RE: North Butte ISL Operation, Permit No. 632

BOND RELEASE INSPECTION REPORT

SUBJECT: Cameco Resources' North Butte Project

PERMIT NO.: 632

Photo No. 14

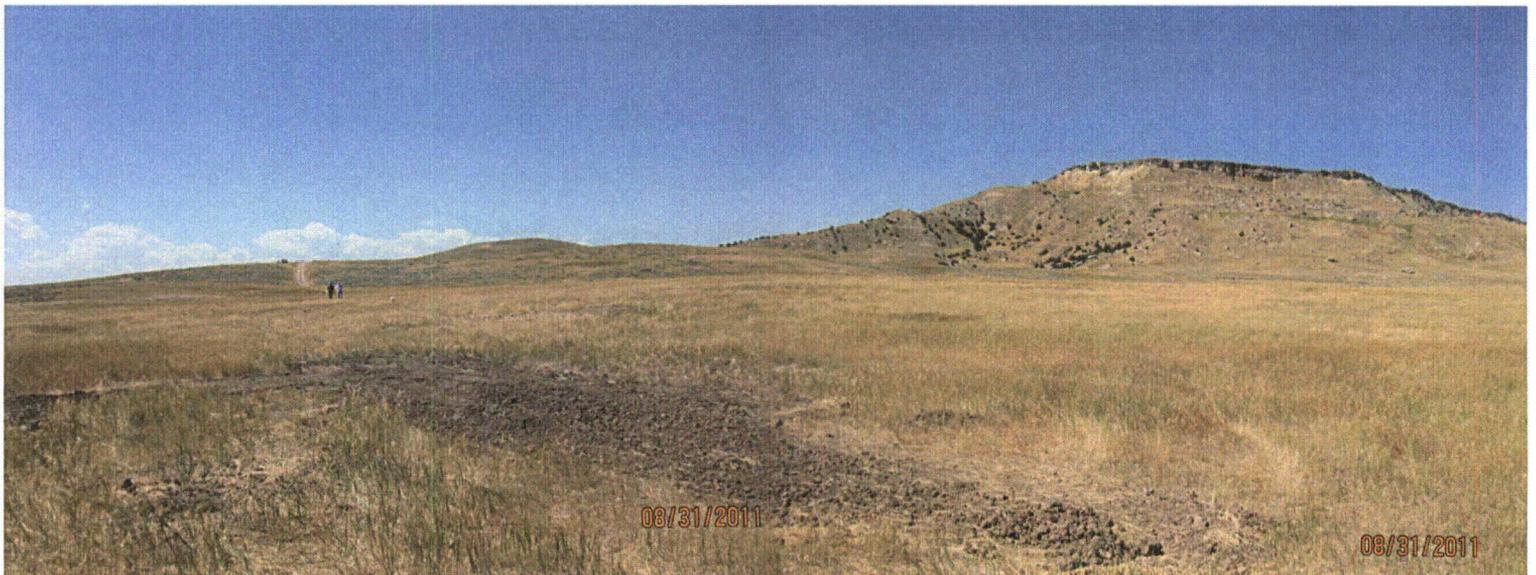
There were only a few areas where some remedial work was requested. One was Drill Hole No. 13-692 where a quantity of subsoil had been left covering topsoil at some distance from the location (Photo No. 6). Another was near Drill Hole 13-596's location for some bentonite, either drilling mud or chips, had been left exposed at the surface, possibly from abandonment of an old hole left over from historic drilling operations (Photo No. 14). Cameco was requested to remove the bentonite and bury it properly.

Looking north at bentonite left on surface near location of Drill Hole 13-596. PRI has agreed to clean up area which may be related to filling of an earlier abandoned drill hole.
